SUZUKI MOTOR CORPORATION  
SERVICE DEPARTMENT

**RE: Recall Campaign for VZ800, VL800/T/Z K5/6 Ignition Switch**

## VZ800, VL800/T/Z K5/K6 Ignition switch lead wire rerouting procedure

### 4. Check and reroute the lead wire

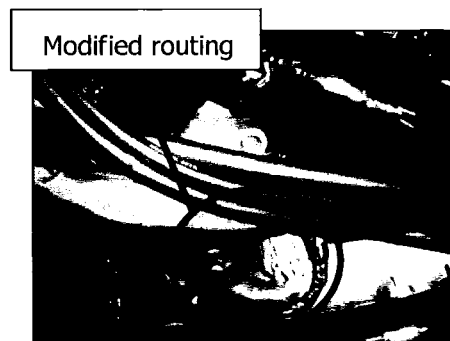
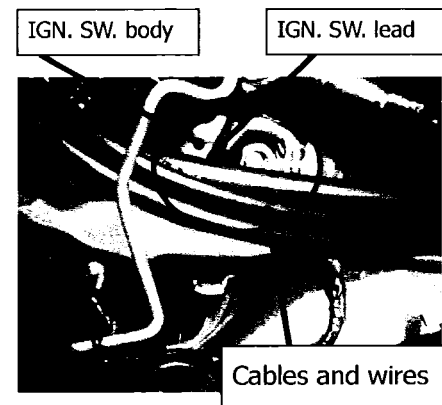
Ignition switch lead wire of these models is routed behind the switch body, with main harness, clutch cable and throttle cable. Due to tight layout on this position, outer cover of lead wire may be rubbed and damaged causing short circuit. When this lead wire short circuit with ignition switch, fuse will be burned causing engine stall due to electric power supply down.

If the ignition switch lead wire is pinched in between ignition switch body and cables, remove throttle cable guide and reroute the lead wire. Ignition switch lead wire and coupler should be located underneath the switch body, see below picture.

If ignition switch lead wire is already damaged, replace the ignition switch as LOCK SET which consists of ignition switch, fuel tank cap, side cover lock and helmet lock, referring service manual.
